Stability Pathfinder Phase 2 FAQ

Updated 04/10/21

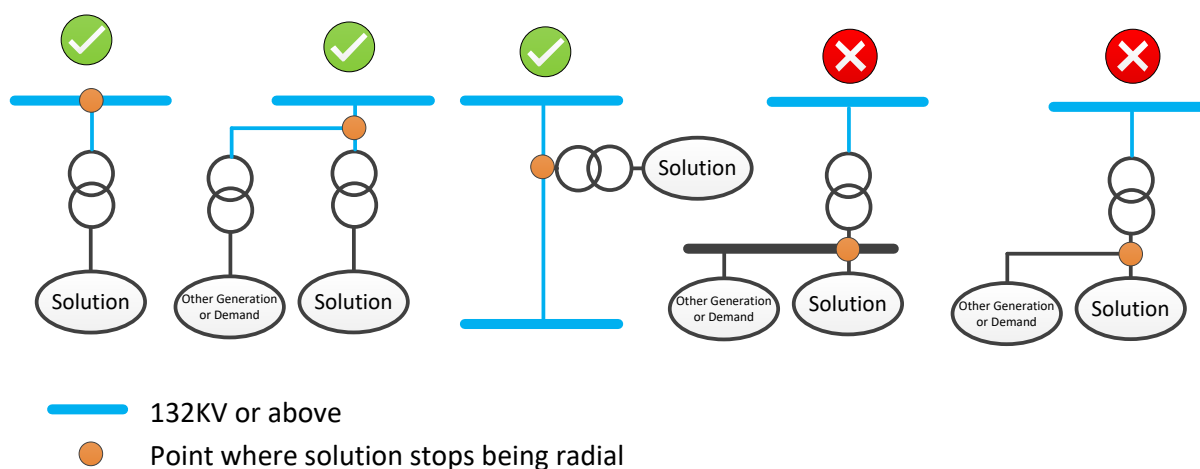
30. Why were these 8 locations picked? (added 06/11/20)

This is based on our system needs and studies. See Q13 for more information.
